DOCUMENT CHANGE NOTICE (DCN)

DOCUMENT No. (DOC-REV-GP. ID)	TITLE	NEW REV.
D980183-A-D	LOS Clamp, Short	B
D980184-A-D	LOS Clamp, Long	B

REF ID		PART or DRWG No.		CDS		MATERIAL	
				PARTS and MATERIAL LIST		LIGO	
						CALIFORNIA INSTITUTE OF TECHNOLOGY MASSACHUSETTS INSTITUTE OF TECHNOLOGY	
						LOS CLAMP, SHORT	
						SCALE 1:1	
						SHEET 1 OF 1

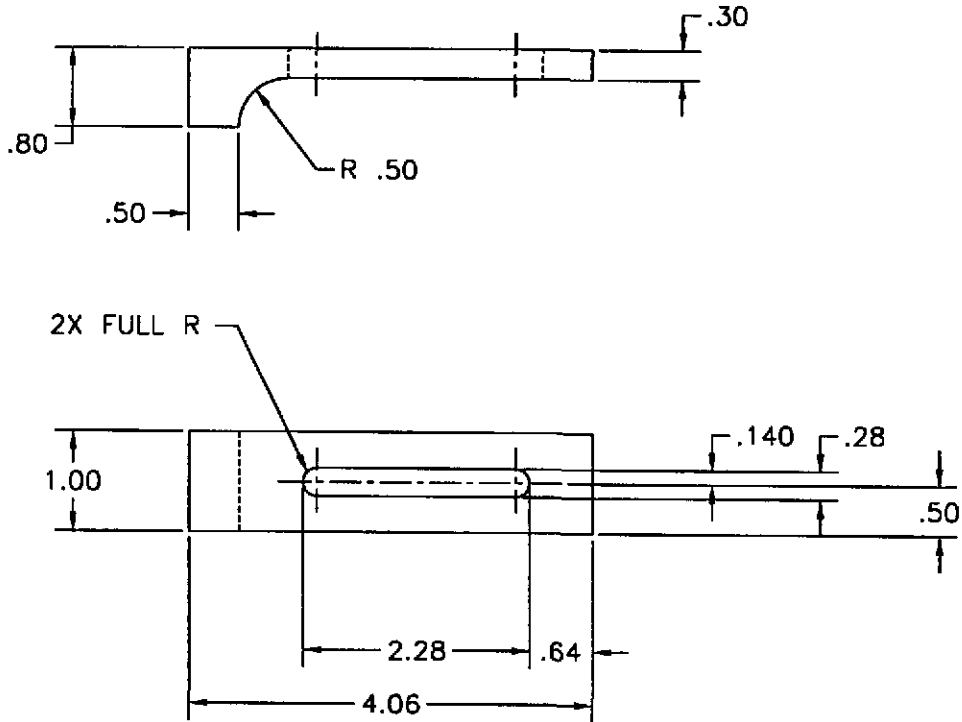
CHANGE DESCRIPTION (FROM/TO): Change material designation from 304 SST to 303 or 304 SST.

Add notes to the drawing.

REASON FOR CHANGE: Material change to save money on machining. Invoke Fab Spec to address special machining and handling instructions of in-vacuum components.

NOTES: UNLESS OTHERWISE SPECIFIED
 1. BREAK ALL SHARP EDGES
 2. SPECIFICATIONS COVERING THE FABRICATION OF THIS CLAMP ARE IN THE LARGE OPTIC SUSPENSION (LOS) FIXTURES AND COMPONENTS FABRICATION SPECIFICATION, LIGO-E970155.

UNLESS OTHERWISE SPECIFIED			
TOLERANCES:	DIMENSIONS ARE IN INCH		
FUNCTIONAL:	FINISHED SURFACE DIM		
ASSEMBLY:	BREAK CORNERS .010		
	TWO PLACE DECIMAL & .015		
	THREE PLACE DECIMAL & .005		
MATERIAL:	HEAT TREAT:	FINISH:	
303 OR 304 SS			
USED ON:	NEXT ASSY:
